LAKEPOINTE MIXED USE MASTER PLAN

Final Supplemental Environmental Impact Statement

***King County Department of
Development and Environmental Services***

July 1998

Figure 30A

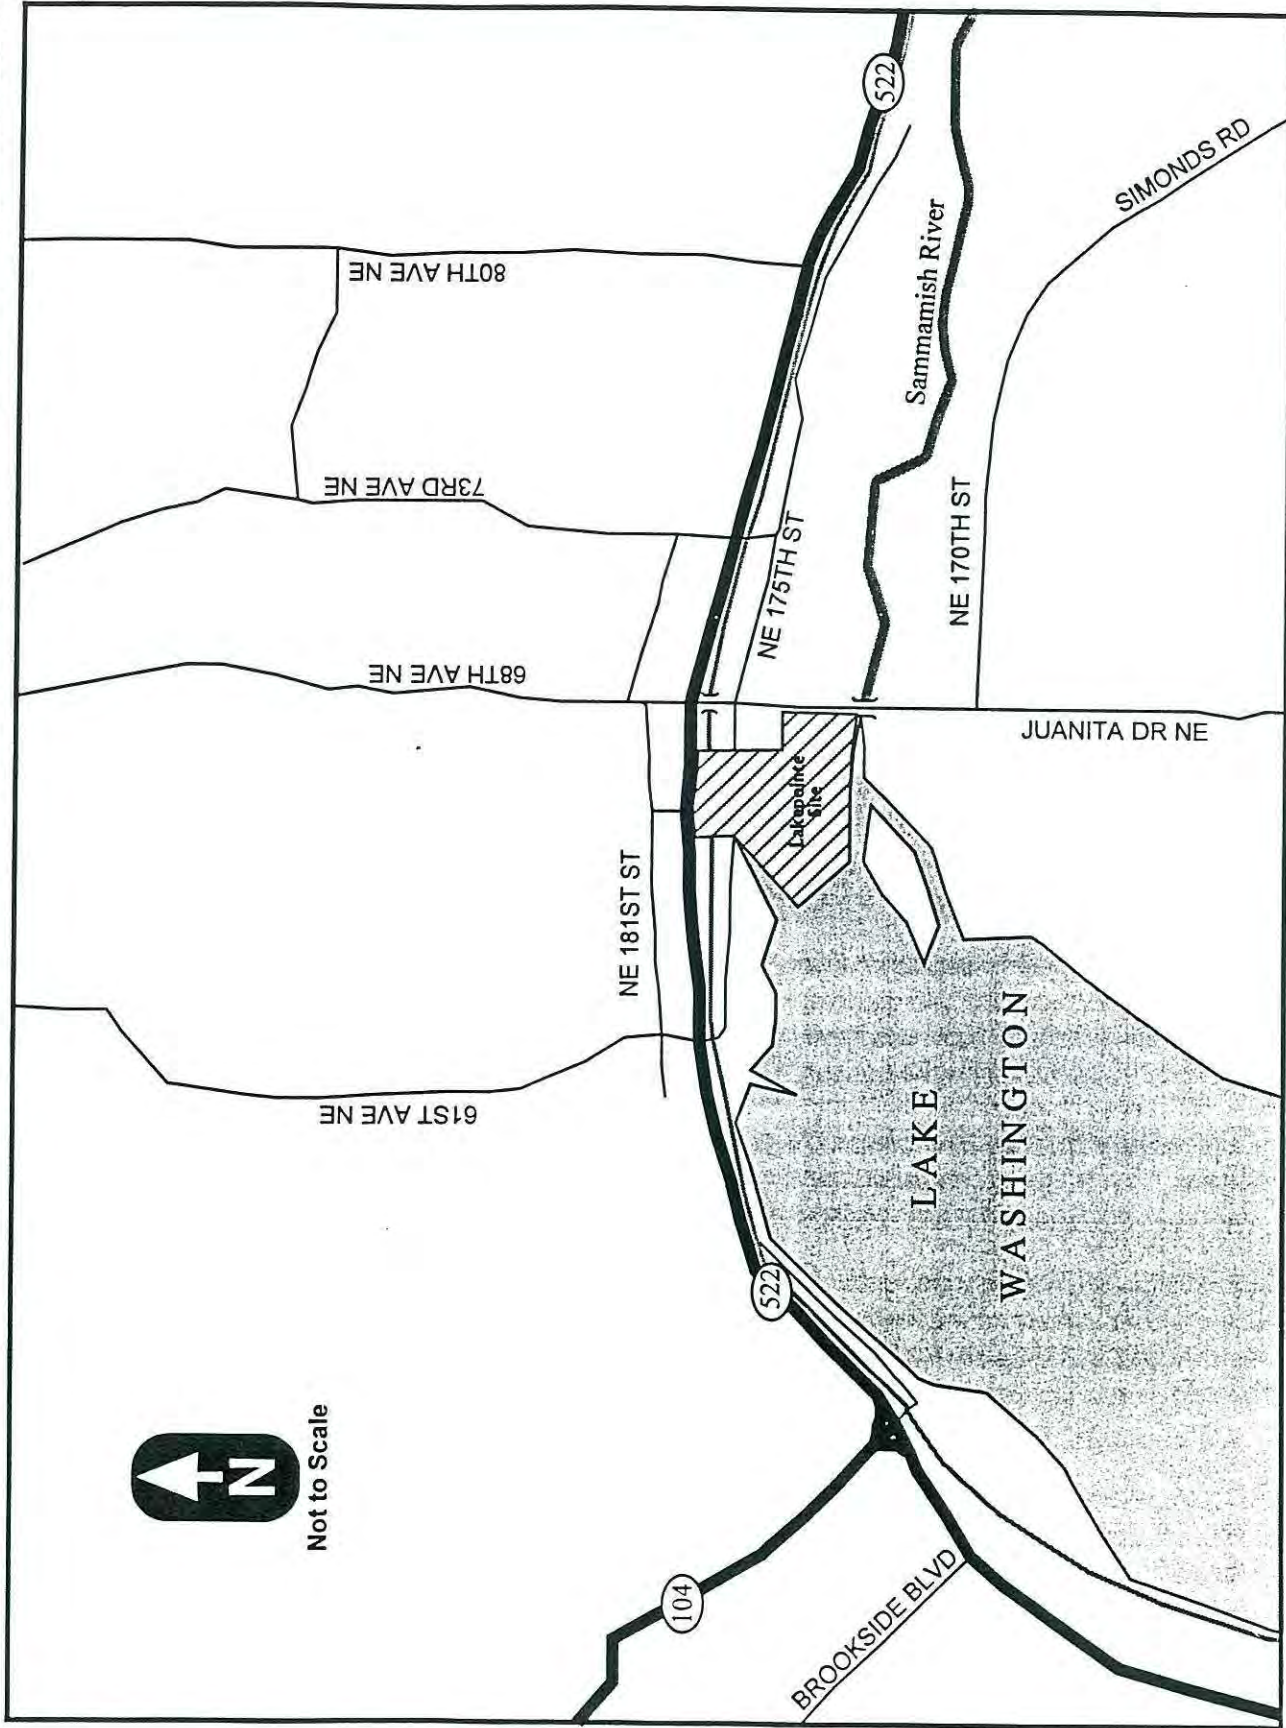
- 18 | Page 3-186. *Figure 30, Road Network Surrounding the Lakepointe Site.* Please update this graphic to state that the eastbound transit-only lane is existing.

- 22 | Page 3-190. *Transit Service.* The text indicates that the eastbound transit lane is complete. As stated before, this must be reflected in Figure 30. There should also be a graphic for transit service which shows the bus routes which serve this area.

18. Figure 30A of this Final Supplemental EIS indicates the transit-only lanes on both sides of SR 522.

Figure 33A

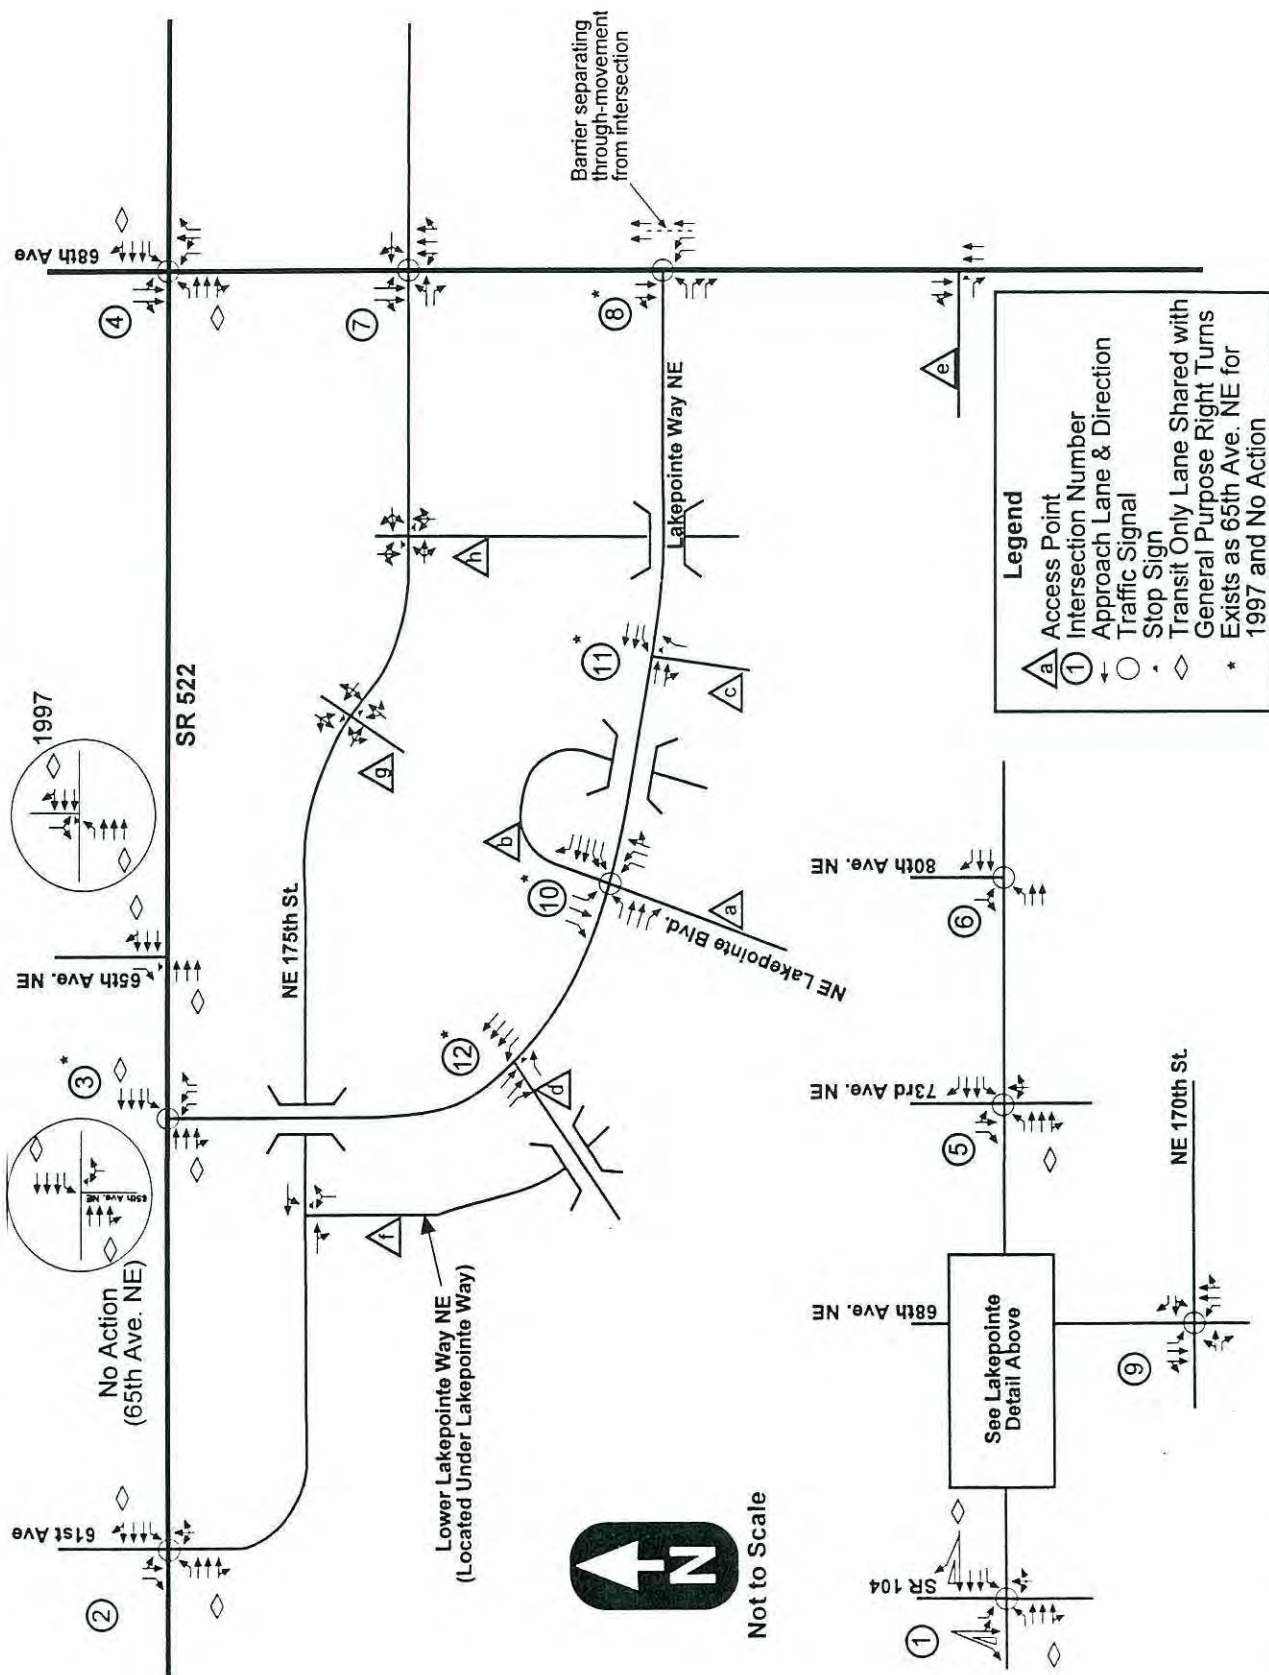
- 26 | Page 3-194. *Figure 33, Proposed Lane Configuration.* Will right turns be permitted at Building A driveway? Will Building B driveway have an exclusive right turn lane? What are the movements allowed at the Lakepointe driveway access to 68th Avenue Northeast?

1. Refer to Figure 3A of Chapter 2 (Revisions to the Proposed Action) and Figure 33A of Chapter 3 (Response to Major Issues) for illustrations of the proposed street layouts, intersection patterns, and access.

2. The proposed lane configurations shown in Figure 33A in the updated transportation analysis are consistent with the proposed mitigation.
3. Subsequent to the issuance of the Draft Supplemental EIS, a updated transportation analysis was prepared (see Chapter 3 of this Final Supplemental EIS for the updated analysis). For the updated transportation analysis, 1997 WSDOT Office of Urban Mobility traffic counts on SR 522 were used and factored to 2005 using the Office of Urban Mobility background growth assumption of 2-percent growth per year.

Figure 36A

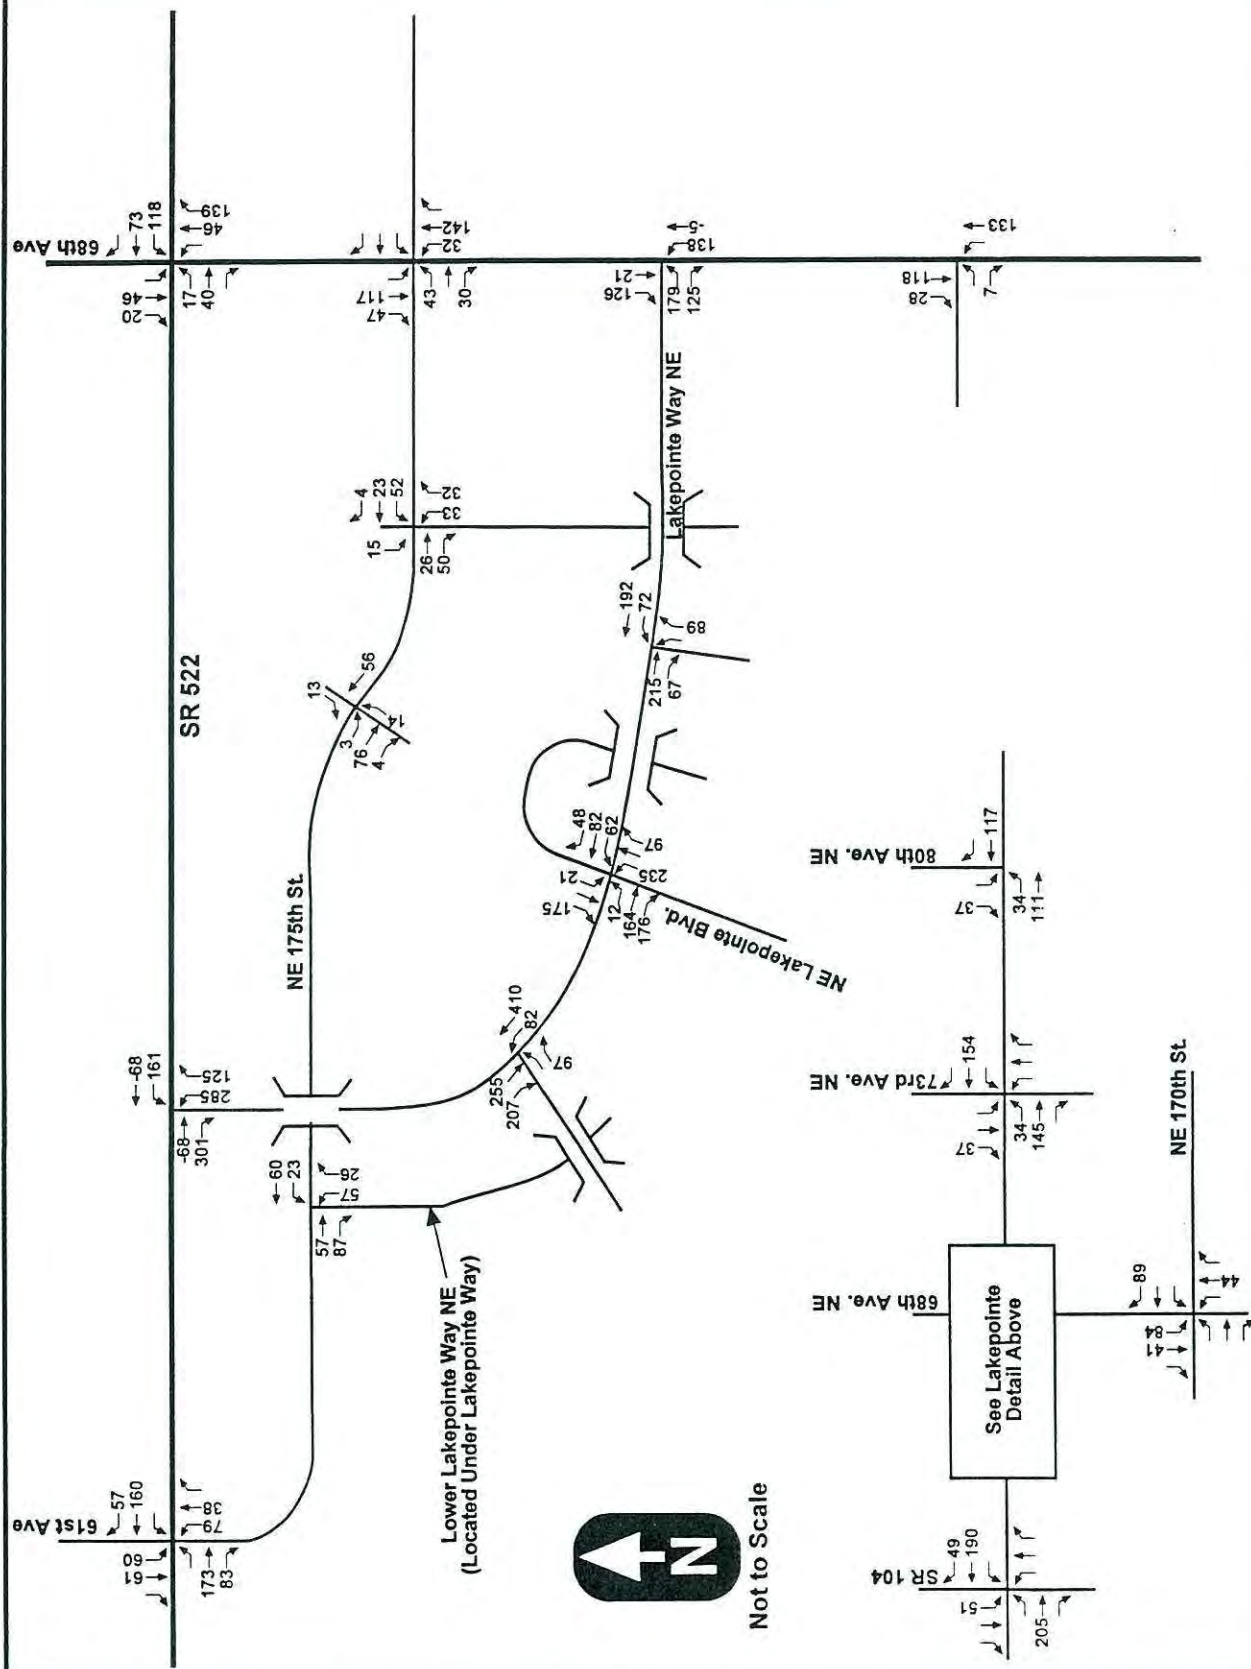
- 34 | Page 3-200. *Figure 36.* There are a number of significant errors on the 2005 AM Peak Hour with Site graphic. First, there is the error of trips gained and lost between 61st Avenue Northeast and SR 104. There are 37 site destined trips that leave SR 104 eastbound and become 155 trips at 61st Avenue Northeast. If 155 trips arrive at 61st Avenue Northeast, probably at least 150 of them will pass through the SR 104 intersection. There is a similar error associated with the trips between Lakepointe Way and Northeast 170th Street on 68th Avenue Northeast. The 87

35. The updated transportation analysis does not include negative trips, except for pass-by volumes at the SR 522/Lakepointe Way and 68th Ave NE/Lakepointe Way intersections. These pass-by trips are subtracted from the through movement and added to the turning movements into and then out of the site. Please refer to Figures 36A and 37A of this Final Supplemental EIS for detail.

Figure 37A

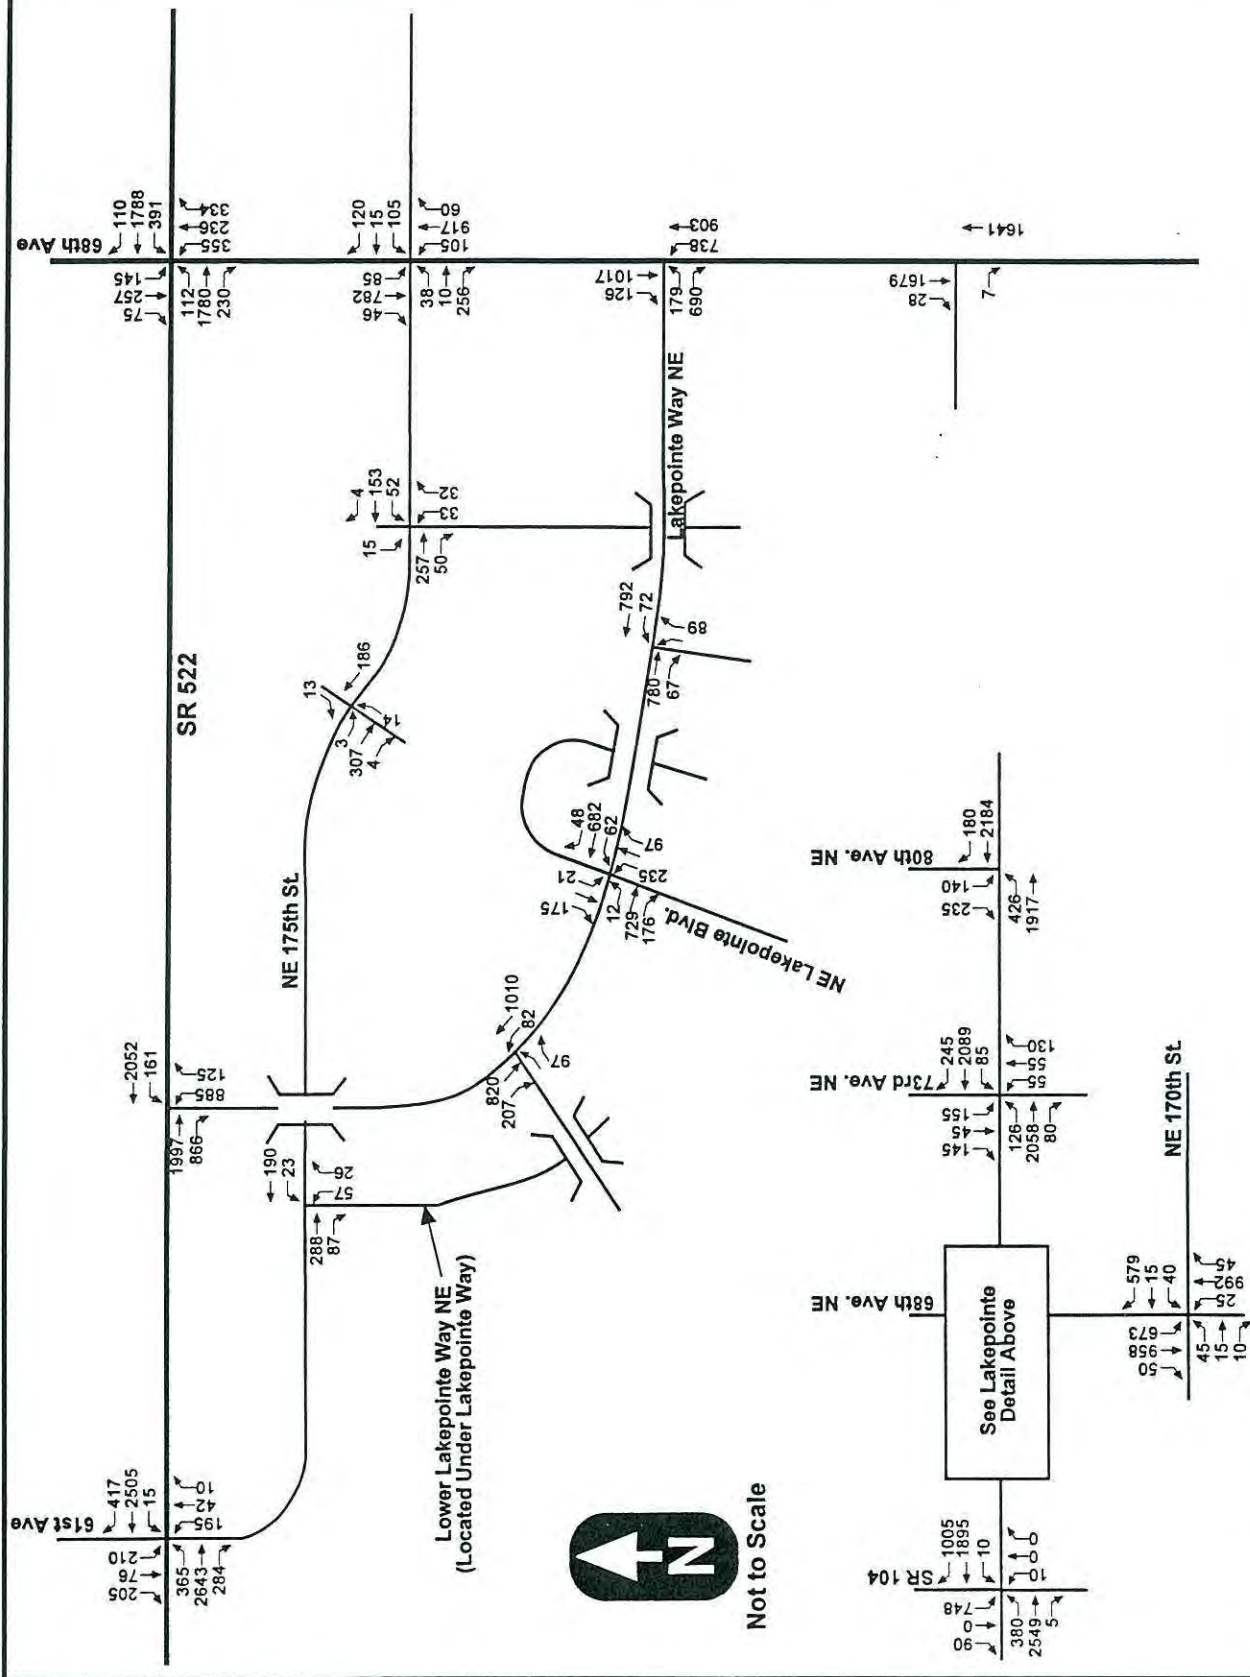
35 Page 3-201. *Figure 37.* The same comments apply to this graphic as apply to the previous one; they must be reevaluated. An explanation of negative trip generation needs to be included. The northbound through movement on Lakepointe Way Northeast at Northeast Lakepointe Boulevard is listed as -12. How does a site generate negative trips? This should be carefully explained.
